Service Bulletin

RRP Service Bulletin No: RRP SB393

Title: Torque Set Screws on Axle Bearing

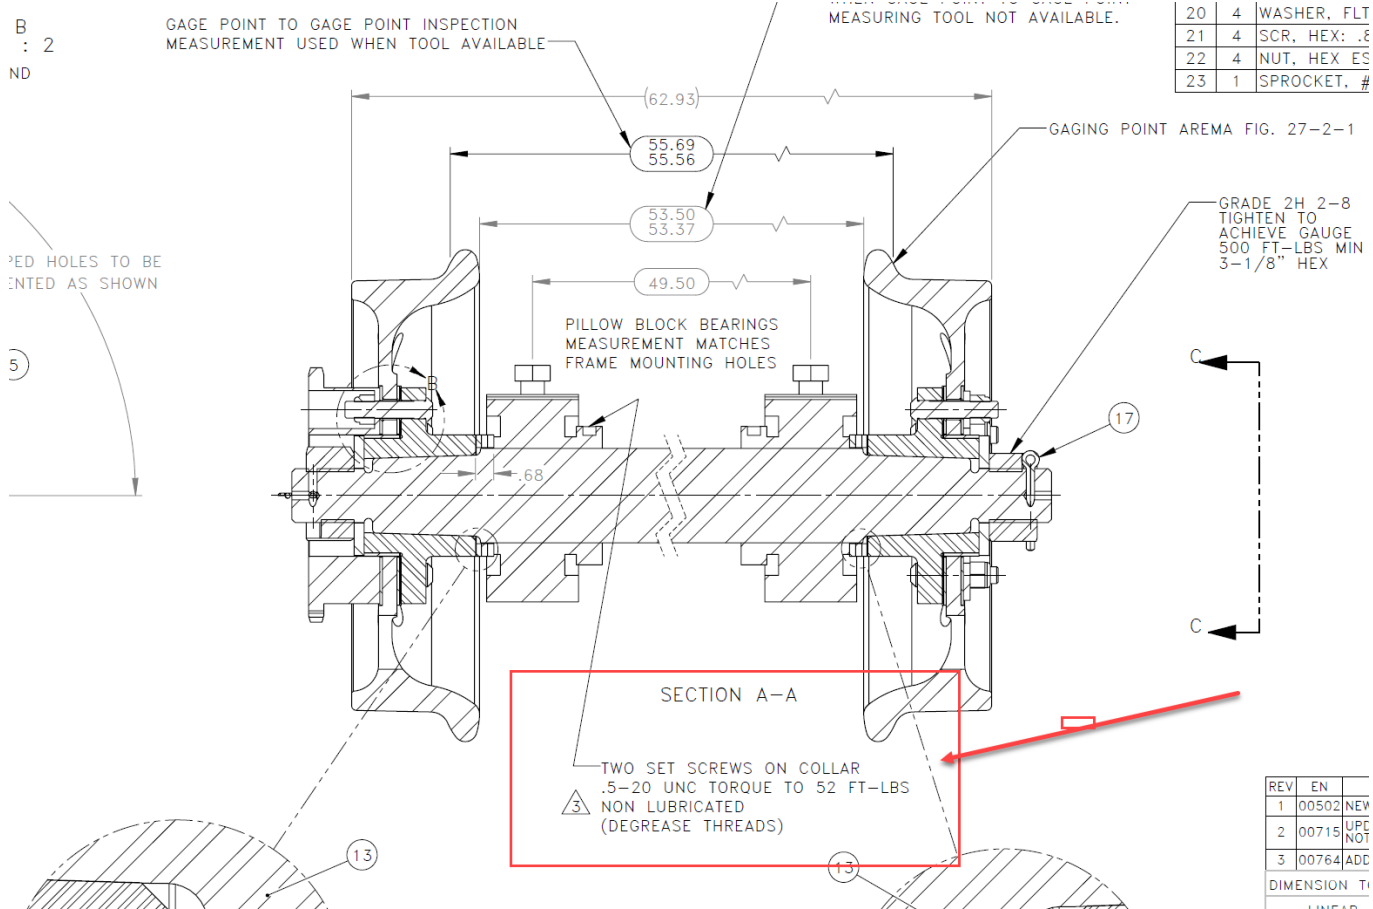
Summary: Set screws on axle may be loose. *Failure to torque set screws can result in both axle and bearing failure.*

IMPORTANT
TORQUE BOTH .5-20 UNC SET SCREWS ON EACH BEARING TO 52 FT-LBS AFTER INSTALLATION ON AXLE ONTO MACHINE.

Resolution: Check axle bearing set screws on **all** machines in operation. Torque both .5-20 UNC set screws on each bearing to **52 ft-lbs.**

On new axles installed onto existing machines, torque both .5-20 UNC set screws on each bearing to **52 ft-lbs.**
